SINGAPORE CIVIL DEFENCE FORCE

Date : 1 Sep 2022

PUBLICATION OF THE CODE OF PRACTICE FOR FIRE PRECAUTIONS IN RAPID TRANSIT SYSTEMS (CPFPRTS) 2022 EDITION

Diagram 1.4.87: Ventilation Opening Size

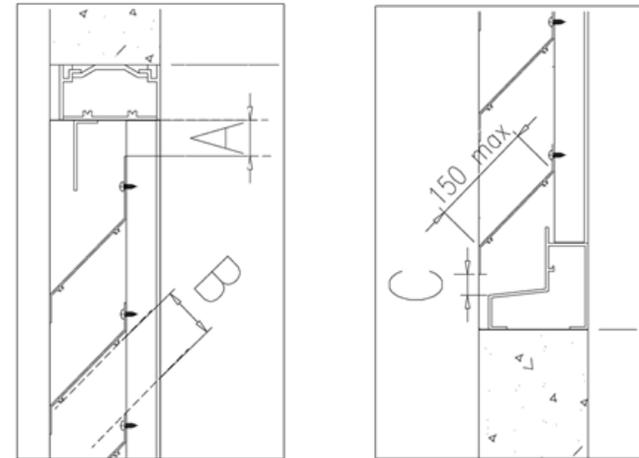
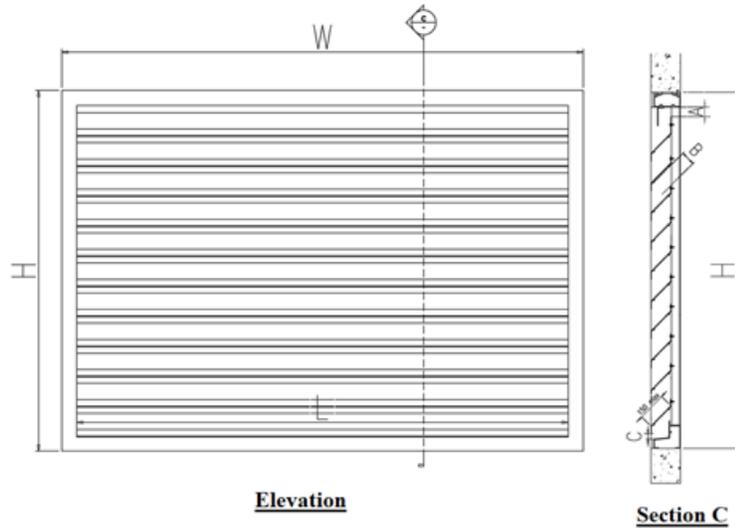
| 14 | 1 Sep 2022 | 1 Mar 2023 | Existing from Fire Code | Nil | <p><i>Cl.1.4.87</i> Ventilation openings</p> <p>“Ventilation openings” refer to fixed natural ventilation openings located in external walls for any space, which shall be always unobstructed, and exclude windows or louvres that are openable or operable. Where fixed louvres are used in natural ventilation openings for exit staircases, smoke-free lobbies or exit passageways they shall consist of a single bank of louvres with blade width not exceeding 150mm, with effective ventilation openings calculated based on the free area</p> |

calculation stated in *Diagram 1.4.87.*

Ventilation opening size for single bank louvres = Free Area = L [A + C + (B x n)]

A = Min opening distance between the top frame and top blade
 C = Min distance between the sill and bottom blade
 B = Min distance between blades
 n = Number of B openings
 L = Min distance between louvres jambs

Diagram 4.2.4j.(2): Markings for Fire Engine Accessway/ Fire Engine Access Road

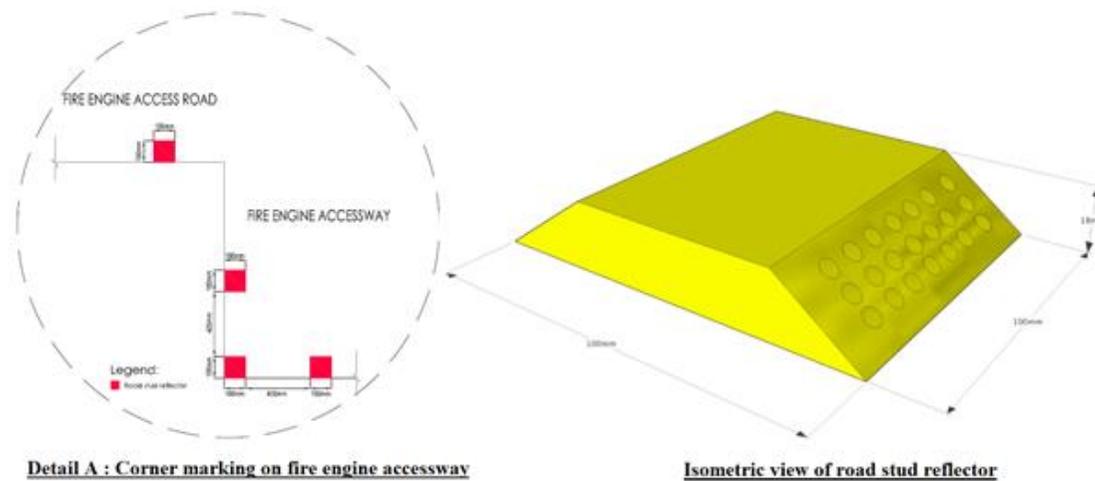
| 33 | 1 Sep 2022 | 1 Sep 2022 | Revised/ Clarification | Existing <i>Diagram 4.2.4e.(3) - 3</i> | See <i>Annex C: Revised Diagram 4.2.4j.(3)</i> |

Diagram 5.2.6 – 1: Block diagram of Typical RTS Station Dual Feeder LV Power Supply Scheme

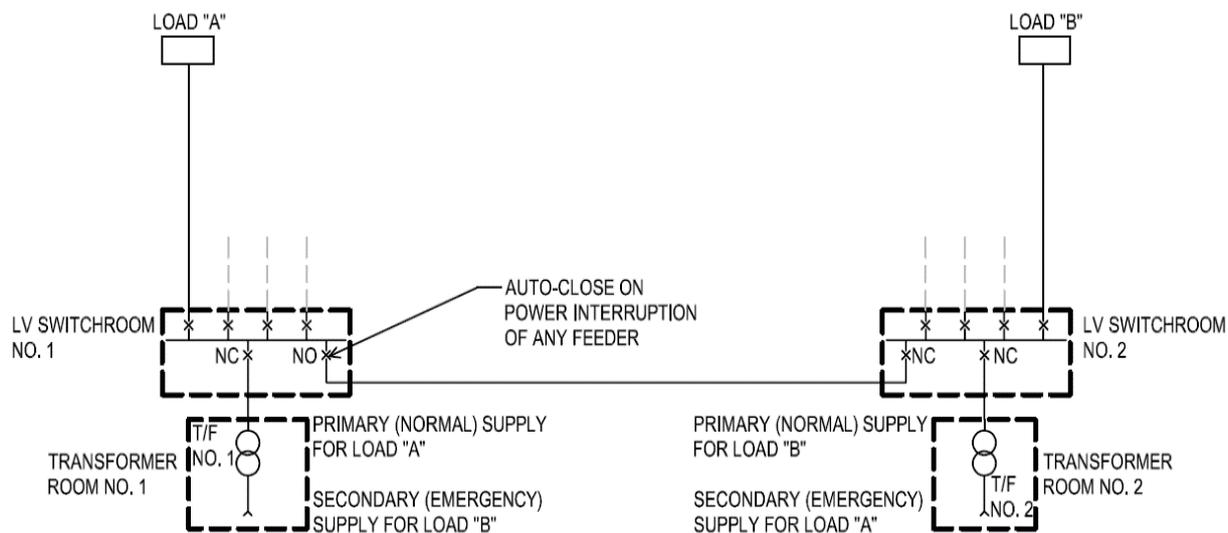
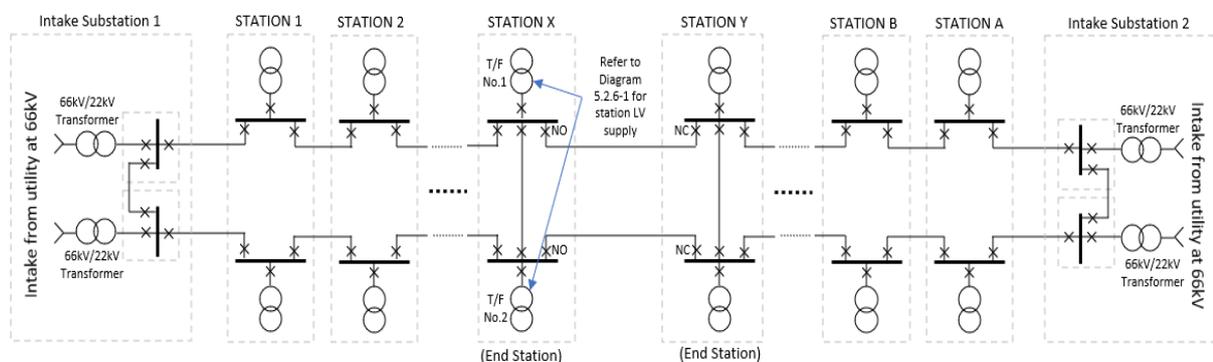
| 27 | 1 Sep 2022 | 1 Sep 2022 | Revised/ Clarification | <p><i>Cl.13.3.2</i> Dual electric feeder</p> <p>Notwithstanding the above, dual feeder power supply are deemed to have been provided with primary and secondary source of power supplies. The primary feeder (primary supply) shall be the normal power supply while the secondary feeder (secondary supply) shall be the emergency power supply. (See <i>Diagram 13.3.2- 1 & 2</i>)</p> | <p><i>Cl.5.2.6</i> Dual electric feeder power supply</p> <p>Notwithstanding the above, dual feeder power supply are deemed to have been provided with primary and secondary source of power supplies. Dual electric feeder power supply is deemed to have been provided with primary and secondary source of power supplies, on condition that the feeders are tapping power supply from different segregated blocks of the power grid. The primary feeder (primary supply) shall be the normal power supply while the secondary feeder (secondary supply) shall</p> |

| | | | | | be the emergency power supply. <i>See Diagrams 5.2.6 – 1 & 2 below.</i> |

| 34 | 1 Sep 2022 | 1 Sep 2022 | Revised/ Clarification | Existing <i>Diagrams 5.2.6 – 1 & 2</i> | See <i>Annex C: Revised Diagram 5.2.6 – 1 & Diagram 5.2.6 - 2</i> |
